BRITISH RAILWAYS

Notice to Trainmen, etc.

MULTIPLE ASPECT SIGNALLING

OLD OAK COMMON

OLD OAK COMMON (FIELD SIDINGS)

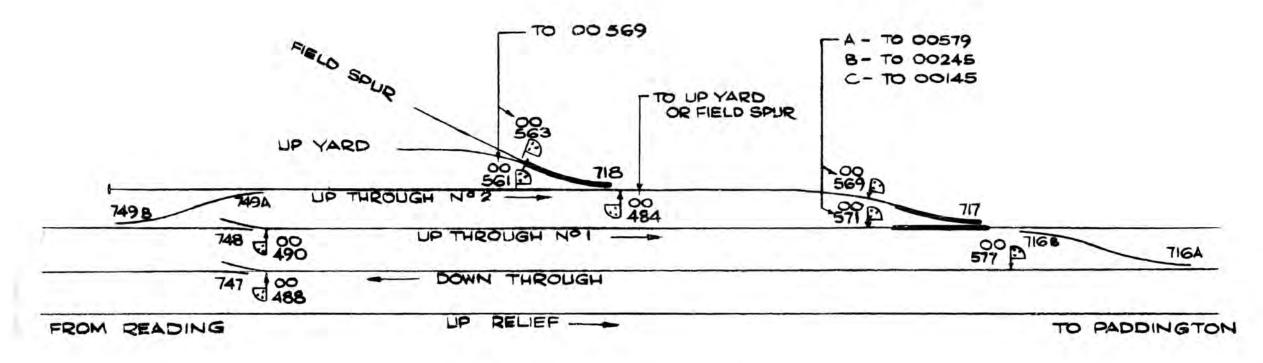
New permanent way will be brought into use as shown on the attached diagram.

N.B. The lines shown on the attached diagram as Down Through, Up Through No. I and Up Through No. 2 will in future be known as the DOWN RECEPTION, UP RECEPTION No. I and UP RECEPTION No. 2 respectively.

The route indicators on signals 00.241, 00.341 and 00.541 will all be taken out of use.

Ground Position Light signal 00.492 at the west end of the Up Siding will be taken out of use.

Ground Position Light signal 00.561 will be repositioned to the rear of the new connection in the Up Reception No. 2 Line and Ground Position Light signal 00.571 will be repositioned to the rear of the new connection from Up Reception No. 2 Line to Up Reception No. 1 Line as shown on the attached diagram.

The Ground Position Light signals, 00.563, 00.569 and 00.484 shown on the attached diagram will be brought into use.
